# Assessment against planning controls: section 4.15, summary assessment and variations to standards

## 1.1 Section 4.22 'Concept Development Applications'

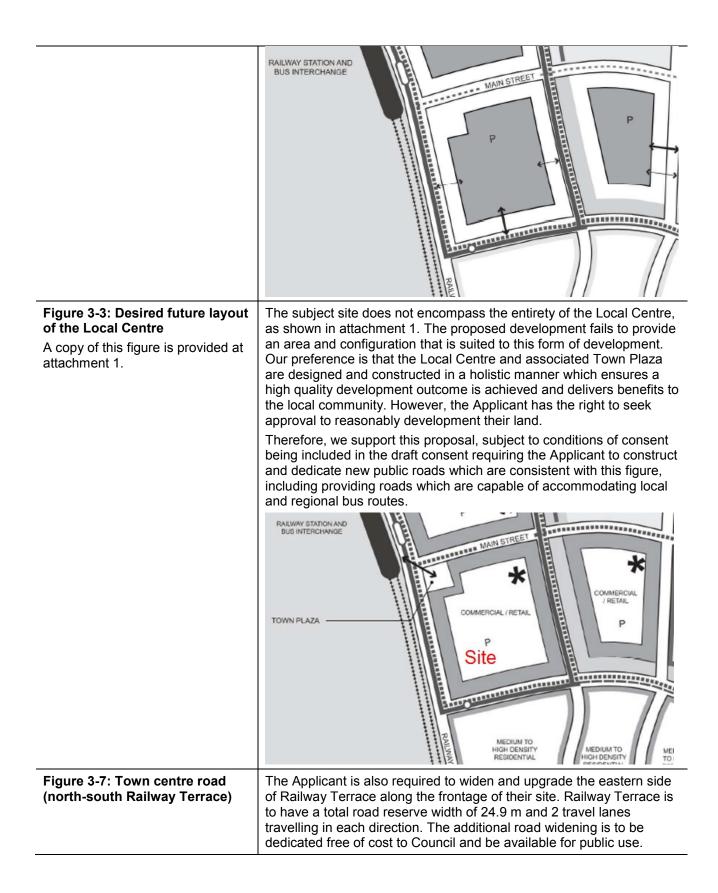
The proposal fails to provide a local centre which is linked to the surrounding road network and provides access for the use of all residents. It provides an isolated development outcome which fails to support community interaction and is not supported by public road access and infrastructure.

Control	Comment
Figure 2.1 – Precinct Indicative Layout Plan	The proposal will not deliver the roads in the Indicative Layout Plan and so fails to provide a new road network consistent with the strategic rezoning of the Precinct. Conditions of consent have been provided in the draft consent requiring the Applicant to construct the new public roads in line with the Indicative Layout Plan and dedicate the new public roads to Council for public use.
Figure 2.4 - Areas of potential	The site is identified as lower salinity risk.
salinity and soil aggressivity risk	The recommendations of the salinity assessment reports have been included as conditions in the draft consent.
Figure 2.8 Precinct road hierarchy	The proposal fails to satisfy the requirements of the Precinct road hierarchy. Conditions of consent have been included in the draft consent requiring the new public roads to be delivered by the Applicant consistent with this Precinct road hierarchy. In addition, Jacqui Avenue is to be widened to a 13 m carriageway as required by RMS (refer to Section 7 of the Assessment Report for further details). Therefore, the total road reserve is to have a width of 20 m to enable bus access).

Conditions of consent are required to be imposed requiring these matters to be met.

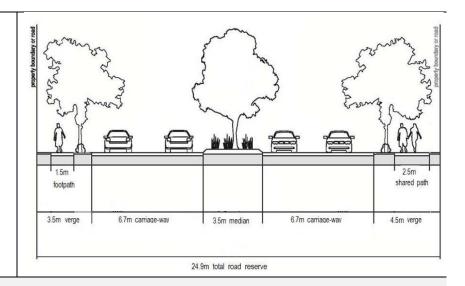
Figure 3-2: Traffic circulation and parking within the centre	The proposed vehicular access points are generally consistent with this figure. However, suitable access via the eastern part of the site (Minerva Street) is not provided, as discussed at Section 7.8 of the Assessment Report.
	The Applicant proposes to provide private access driveways until such time as Council acquires the land and builds permanent roads. As a result, access will not be available to pedestrians, cyclists and vehicles, and access to the development's waste collection and loading areas will not be available. We have provided conditions of consent in the draft consent requiring
	the Applicant to construct and dedicate new public roads which are consistent with this figure and the ILP, including providing roads which are capable of accommodating local and regional bus routes.
